**PLANNED UNIT DEVELOPMENT,  
PLANNING APPROVAL &  
SUBDIVISION STAFF REPORT**

**Date: September 5, 2013**

<b><u>NAME</u></b>	Blue Creek Coal Terminal Subdivision
<b><u>SUBDIVISION NAME</u></b>	Blue Creek Coal Terminal Subdivision
<b><u>LOCATION</u></b>	80 Virginia Street (Area bounded by CSX Railroad, New Jersey Street, Old Water Street, and Mobile River, extending to the North side of Virginia Street, 465'± East of Conception Street))
<b><u>CITY COUNCIL DISTRICT</u></b>	District 2
<b><u>PRESENT ZONING</u></b>	I-2, Heavy-Industry District
<b><u>AREA OF PROPERTY</u></b>	1 lot / 36.9 acres ±
<b><u>CONTEMPLATED USE</u></b>	Planning Approval to allow a coal handing terminal in an I-2, Heavy-Industry District, Planned Unit Development approval to allow multiple buildings on a single building site, and Subdivision approval to create one legal lot.
<b><u>TIME SCHEDULE FOR DEVELOPMENT</u></b>	After appropriate approvals are obtained.

# DETAIL SITE PLAN

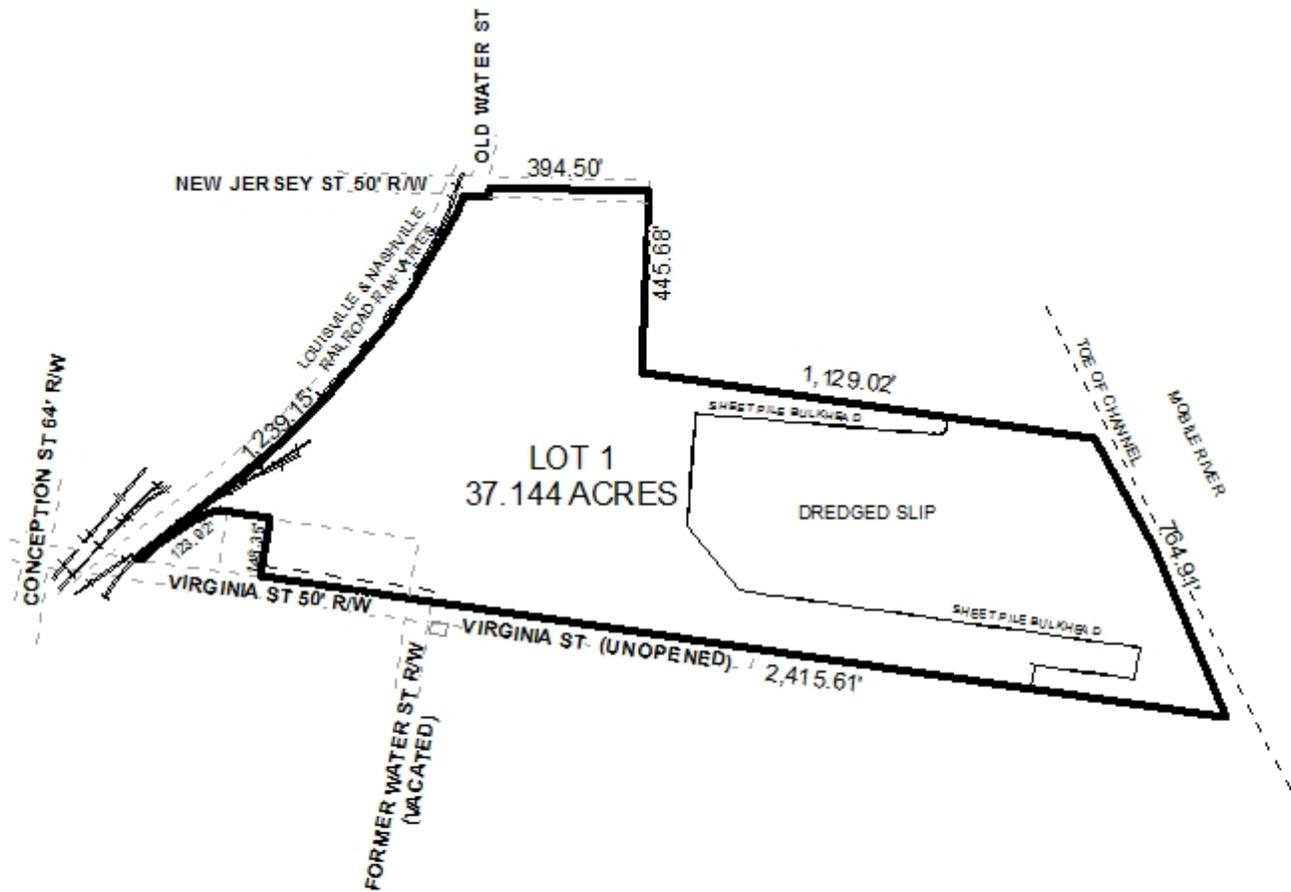
The site plan submitted with the application depicts one proposed curb-cut to Virginia Street. As PUD and Planning Approval review are site plan specific, the site should be limited to the single proposed curb-cut, with the size, design and location to be approved by Traffic Engineering, and to comply with AASHTO standards. It should be noted, however, that the presence of a guard building at the entrance to the site implies to staff that the entrance may be gated. If an entry gate is proposed, it should be depicted on the site plan and it should be set at least 60-feet from the right-of-way of Virginia Street so that emergency vehicles will have sufficient room to turn around if necessary.

The site plan depicts trees and landscape areas on the site. As the site is in an I-2 zone, only frontage trees are required. Calculations by staff indicate that 14 frontage trees are required, to be planted within the 25-foot setback along the Virginia Street frontage. Only 13 trees are depicted, and none appear to be within the setback area. Measurements of the site area by staff indicate that the non-navigable water portion of the site is no more than 22 acres of the total 36.9 acres. As such, the landscape area calculations on the site plan should be revised to only consider the dry land area, not any portion of the site over water (such as a dock), or the water area associated with the Mobile River: essentially any area behind the bulkhead should provide the basis for the landscape area calculations. The site plan and calculations should be revised to reflect the reduced landscape area requirements.

The site plan does not indicate which portions of the on-site access road will be paved, versus surfaced with aggregate or other materials. The site plan should be revised to depict paved

versus aggregate surfacing. Additionally, the parking area should include concrete wheel stops if no curb-and-gutter will be provided.

Finally, the 25-foot minimum building setback line is depicted on the preliminary plat but is not depicted on the site plans. The site plans should be revised to also depict the 25-foot minimum building setback line.

- 1) Revision, if necessary, to label the correct size of the lot in square feet and acres, to match that on the final plat;
- 2) Revision of the site plan to depict any proposed entrance gate at least 60 feet from the edge of the Virginia Street right-of-way;

- 3) Revision of the site plan to depict the 25-foot minimum building setback line from Virginia Street;
- 4) Revision of the site plan to depict 14 frontage trees located within the 25-foot minimum building setback;

- 5) Revision of the site plan and landscape area calculations to only provide frontage and total landscape area based upon only that portion of the site that is actual land (that is, behind the bulkhead);

- 10) Development of the site must comply with all local, state and federal regulations regarding development within a flood zone;
  - 11) Revision of the site plan to indicate which portions of the on-site access road and parking area will be paved in asphalt, concrete or similar, versus aggregate;

- 12) Depiction of concrete wheel stops in the parking area if no curb-and-gutter will be provided;
  - 13) Submission of a revised site plan to the Planning Section prior to the signing of the final plat; and
